**INFORMATION TECHNOLOGY –
SMALL COMPUTER SYSTEM INTERFACE 3 (SCSI-3) –
PART 351: SCSI-3 Medium changer commands (SMC)**

International Standard ISO/IEC 14776-351 was prepared by subcommittee 25: Interconnection of information technology equipment, of ISO/IEC joint technical committee 1: Information technology.

Figure 1 — General structure of SCSI standards

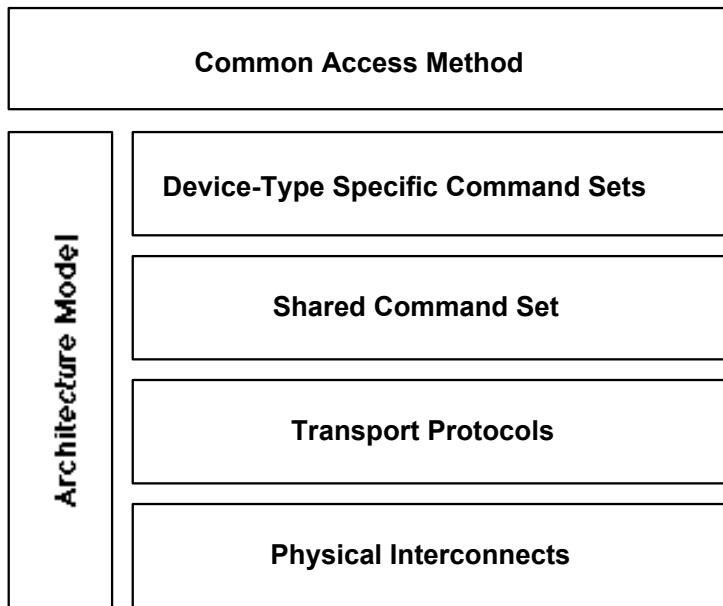
Deleted: is intended to show
